FEMA Levee Certification
Ventura County, California

Ventura River Levee (VR-1)
Pacific Ocean to Canada de San Joaquin

Evaluation Report
February 20, 2009

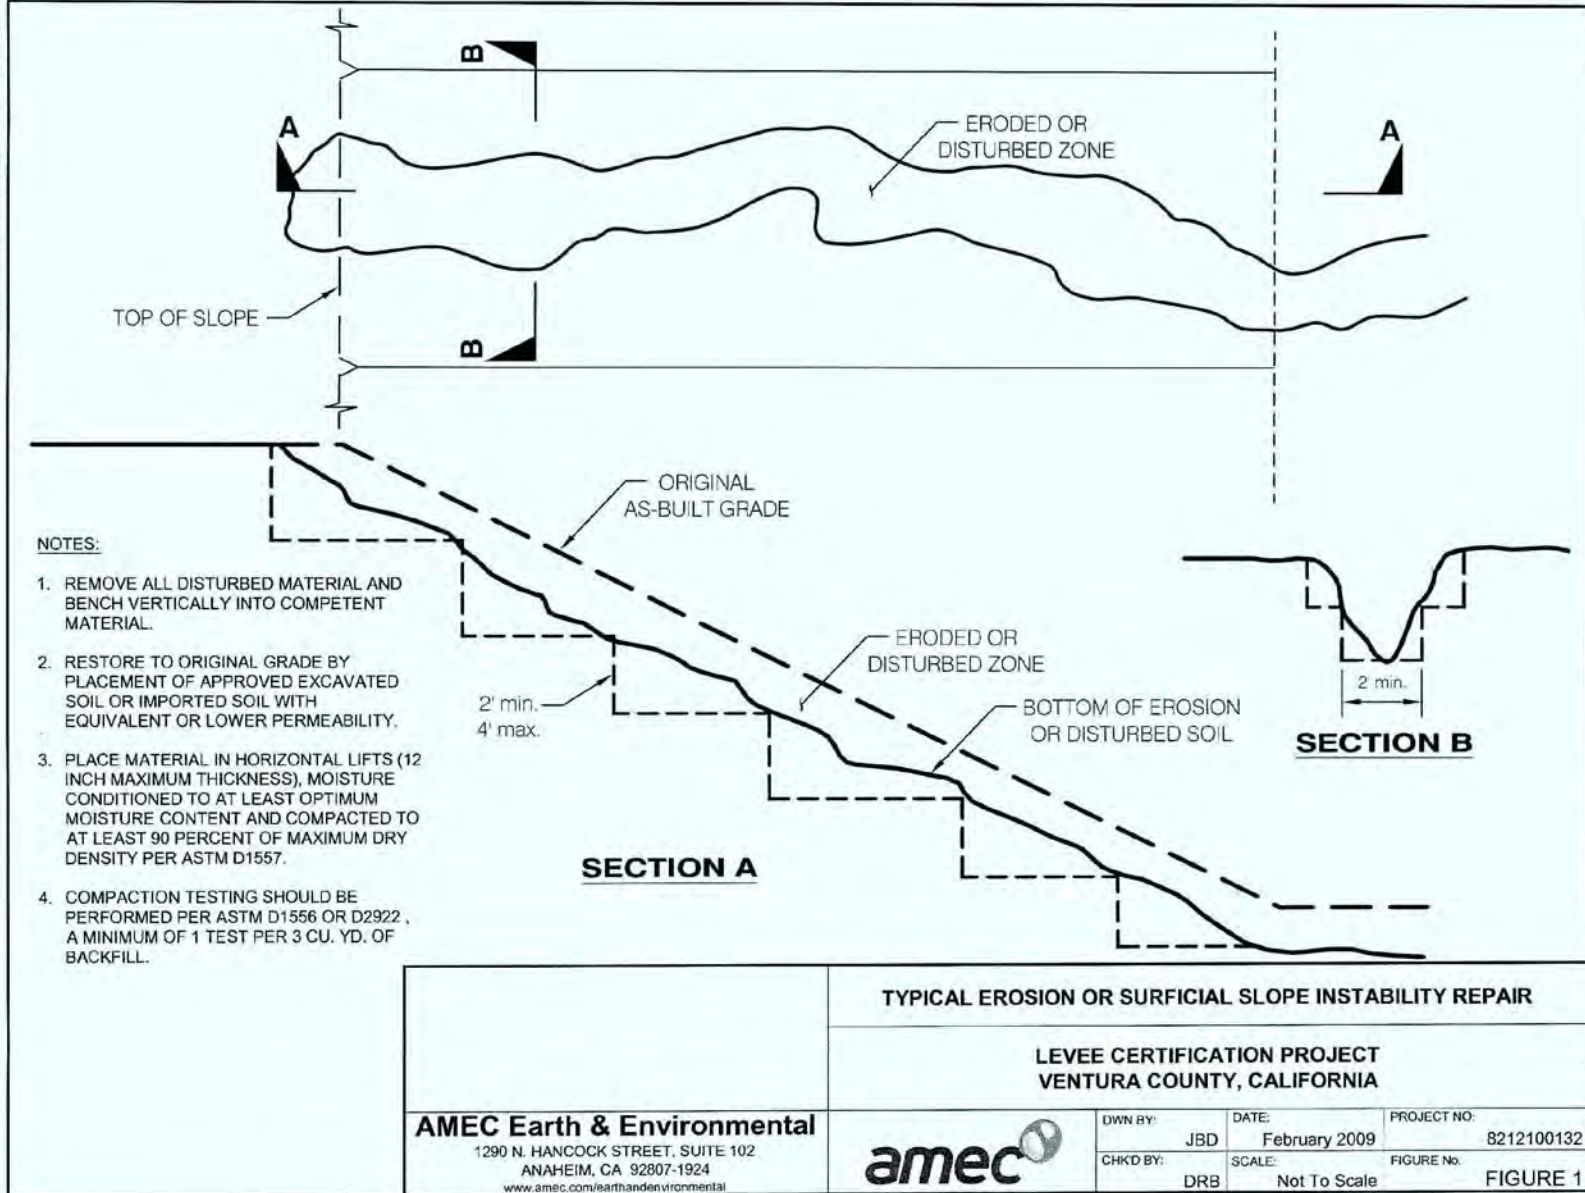
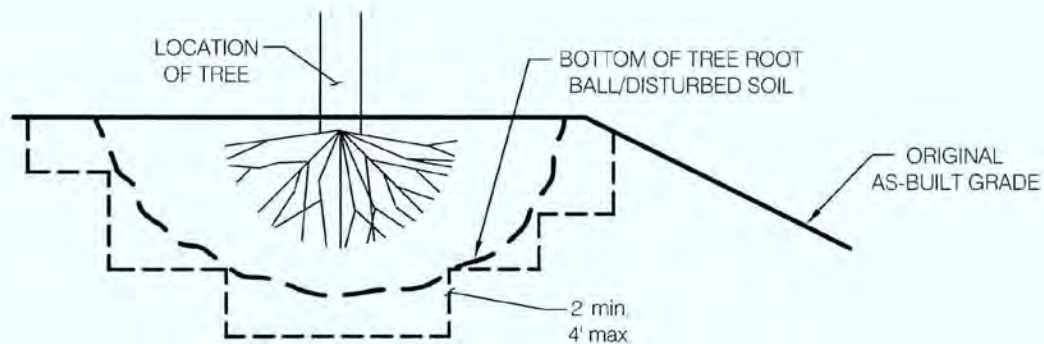
<p>4. Can Tetra Tech provide specs for compaction and grading requirements? Discuss major and minor repair examples.</p>	<p>Compaction requirements are detailed on the attached Figures 1 and 2. Major repair examples include any erosion feature that is deeper than 1 foot or that is greater than 2 feet wide. Major and minor animal burrows are discussed in item 1.</p>
<p>5. Can in-kind materials be used for backfill?</p>	<p>In-kind backfill would be materials free of organic or deleterious debris that has similar or lower permeability than the levee material. These materials could consist of excavated soil, imported soil, concrete, or slurry, and shall be evaluated by the testing and materials lab.</p>
<p>6. Discuss documentation/inspection requirements for verification of grading.</p>	<p>The requirements for verification of grading are discussed above.</p>

1. REMOVE ALL DISTURBED MATERIAL AND BENCH VERTICALLY INTO COMPETENT MATERIAL.
2. RESTORE TO ORIGINAL GRADE BY PLACEMENT OF APPROVED EXCAVATED SOIL OR IMPORTED SOIL WITH EQUIVALENT OR LOWER PERMEABILITY.
3. PLACE MATERIAL IN HORIZONTAL LIFTS (12 INCH MAXIMUM THICKNESS), MOISTURE CONDITIONED TO AT LEAST OPTIMUM MOISTURE CONTENT AND COMPACTED TO AT LEAST 90 PERCENT OF MAXIMUM DRY DENSITY PER ASTM D1557.
4. COMPACTION TESTING SHOULD BE PERFORMED PER ASTM D1556 OR D2922, A MINIMUM OF 1 TEST PER 3 CU. YD. OF BACKFILL.
